Technical Bulletin

Nosebox Side Connections

Incorrect Label on Side Terminal Junctions of Liftgate Charging Noseboxes

Figure 1

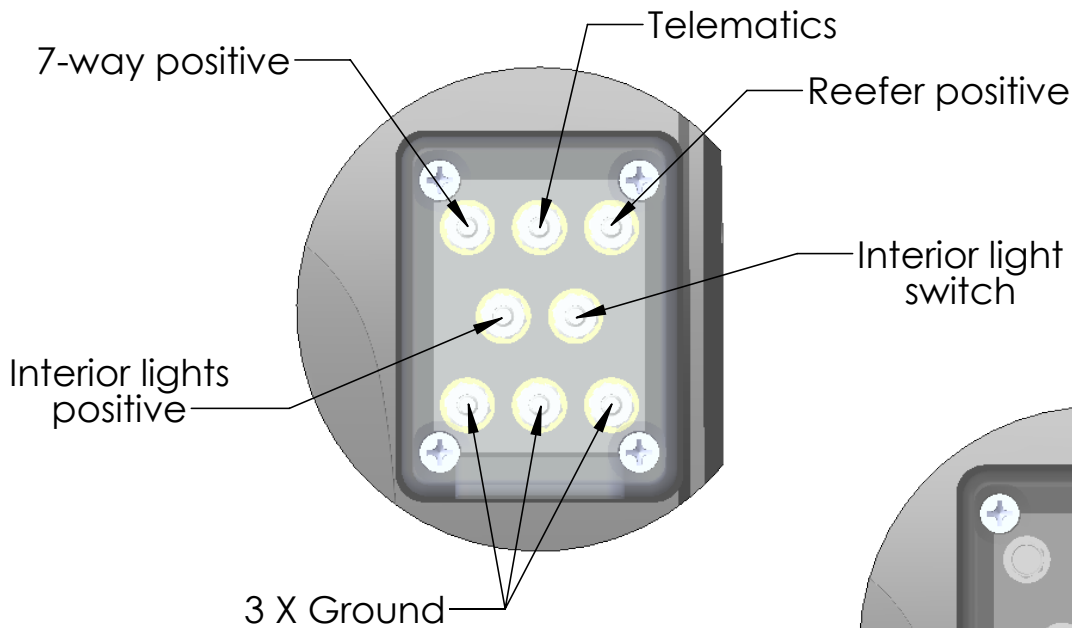
The User Guide had the side terminal junctions for the “Interior Light Positive” and “Interior Light Switch” in opposite positions. Please disregard the original User Guide’s side terminal junction call out and refer to Figures 1 and 2 below for the CORRECT junction call out. This error has been corrected in Doc 2.01 of the Plus/Flex/Max guide and Doc 1.02 of the Select/Direct guide. We apologize for any inconvenience that this may have caused.
